Gull Fuel Facility, 68 – 72 Great South Road, Pokeno – Urban Design Review

Boffa Miskell have been asked to provide an Urban Design Review, as part of the Resource Consent Application for a proposed new Gull service station located at 68 – 72 Great South Road, Pokeno. This review is as part of a further information request from the Waikato District Council (WDC), and is focused on the urban amenity and character of the proposal, as considered against the Pokeno Urban Design Guide (adopted by WDC in 2015) and the Market Square Development Options report, which are both non-statutory guidance documents.

Figure 1 Proposed Gull Fuel Facility

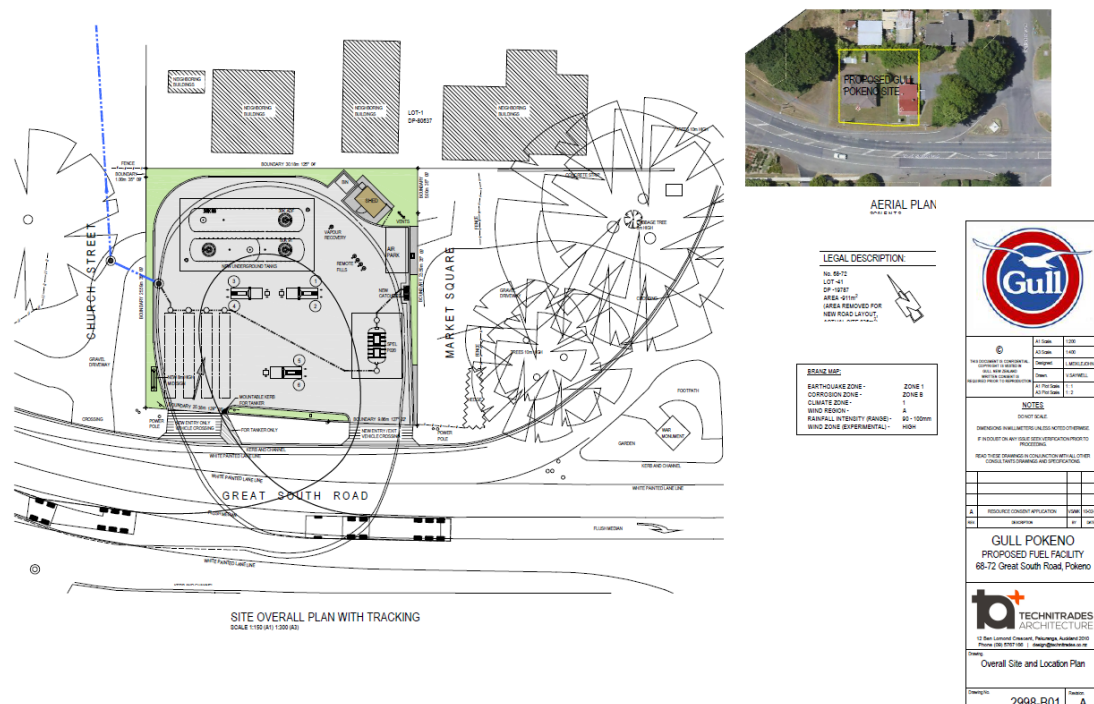
The proposed Gull Fuel Facility site is located directly fronting the North West of the future Market Square site. The design intent as conveyed by the design guide document is that the Market Square is framed by commercial buildings with active building frontages facing inwards towards the square. Due to the nature of the proposed fuel facility design, which is a self-service facility with no actual service station building, this activated frontage is not able to be realised. By its nature, the proposed facility is for use by vehicles only and will not promote any pedestrian movement between the site and the Market Square.

In order to achieve an end design outcome that will not detract from the intentions of the design guide and future Market Square, the boundary interface between the two activities will need to be carefully considered and designed. Currently no boundary treatment or visual mitigation design proposal has been provided for the site. We also note that the current hard surface design proposed for the site allows for very little space for possible soft landscaping along the common boundary with the Market Square.

In our view, if the vision of the Design Guide and Market Square concept design document are to be fully achieved suitable visual mitigation along the common boundary between the proposed Gull fuel facility and the future Market Square is required.

It is our recommendation that in order to suitably mitigate any adverse urban design and visual effects between the site and the Market Square, a combination of suitable boundary fencing and soft landscaping within the development site would need to be installed.

We would recommend that the fencing be of a solid lapped timber design (acoustic type timber fencing) at a minimum height of 1.8 meters, stained in a dark grey or black colour to be visually recessive. The fence should be of a high-quality durable design to ensure longevity and the fence palings should face outwards towards the future Market Square.

We further recommend that a hedge be planted the full length of the South Eastern site boundary. The hedge should be maintained at a height of 3.0 meters and be a minimum width of 1m wide. Hedging should be of a hardy species suitable for its location and growth conditions.

Figure 2: Proposed Market Square Design

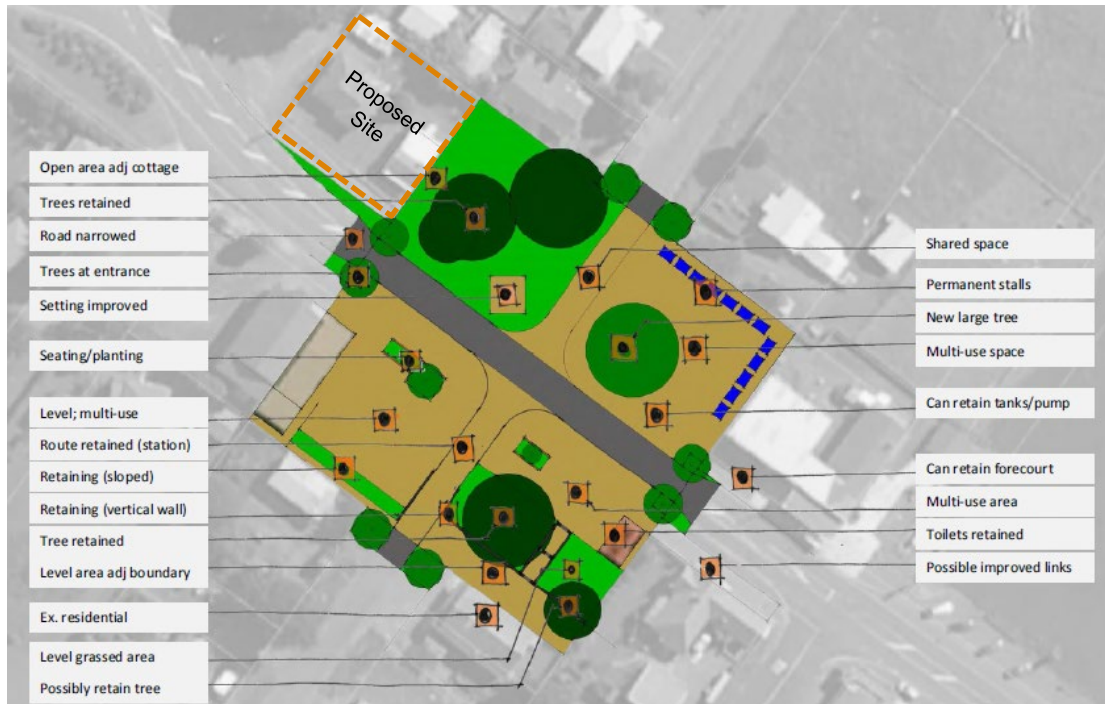
The preferred design proposal for the proposed Market Square, as identified in the Market Square Options Report (Draft May 2014) below, indicates that the future Market Square would be divided into 4 main quadrants, consisting of a combination of hard paved 'plaza' areas and softer lawn spaces with trees. It is notable from the concept design that the northern quadrant of the square, which fronts the proposed Gull site, is predominantly a lawn space with the large existing trees proposed to be retained. These existing trees are likely to provide some visual separation between the proposed fuel facility and the more active plaza areas within the other three quadrants of the Market Square. It is likely that the green lawn area as indicated on the plan, will likely be used for passive recreation purposes, with groups of users sitting under the trees and around the existing cenotaph which is to be retained.
